REMARKS

USSN 09/926,067

FIG. 1

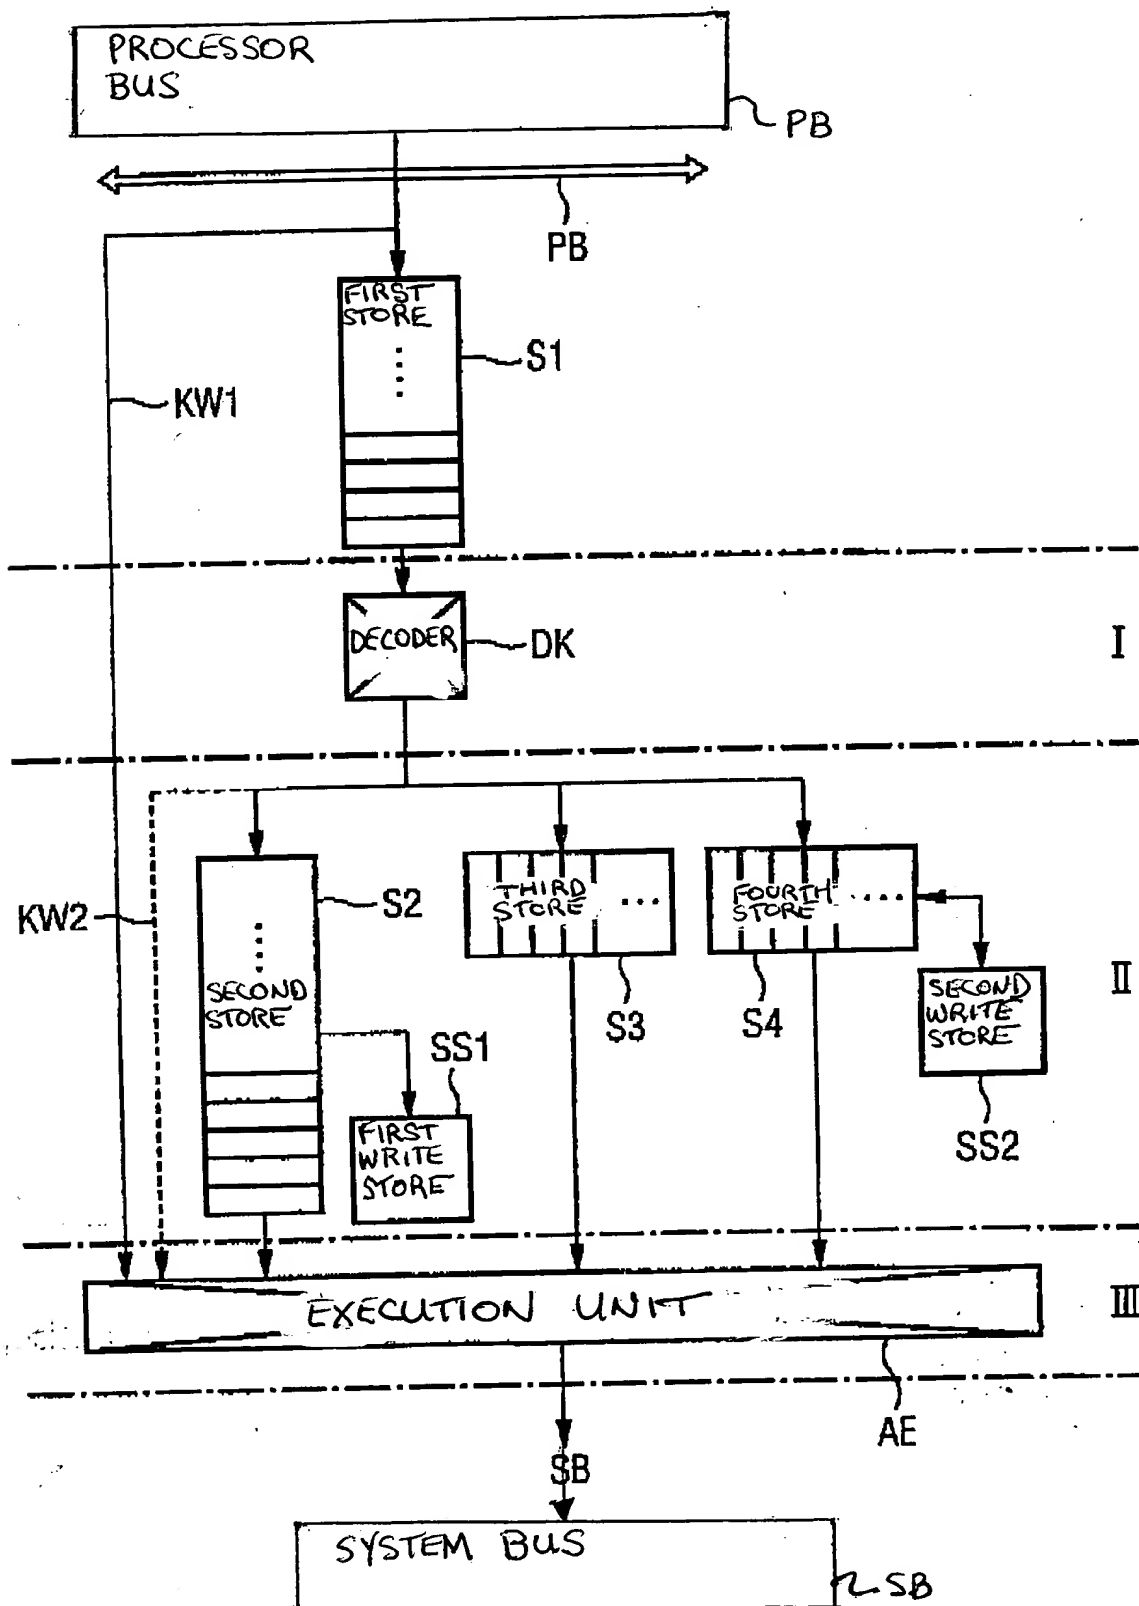
The Examiner objected to the drawing as lacking word labels which, if present, would facilitate an understanding of what each of the elements in the drawing represents. Accordingly, a corrected version of FIG. 1, labeled as "Replacement Sheet 1 of 1", is submitted herewith. An annotated marked-up drawing for sheet 1/1 is also enclosed herewith for the convenience of the Examiner, with additions indicated in red and deletions indicated in yellow. Word labels were added to identify processor bus (denoted as PB in the originally filed version of the drawing), first store (S1), second store (S2), third store (S3), fourth store (S4), decoder (DK), first write store (SS1), second write store (SS2), execution unit (AE), and system bus (SB). The aforementioned terms were used throughout applicant's originally filed disclosure to refer to corresponding elements of FIG. 1. Moreover, a label was added to Replacement Sheet 1 of 1, so as to identify this sheet as including FIG. 1. No new matter was added. Thus, it is submitted that the corrected version of FIG. 1 will facilitate the Examiner's understanding of the various drawing elements.
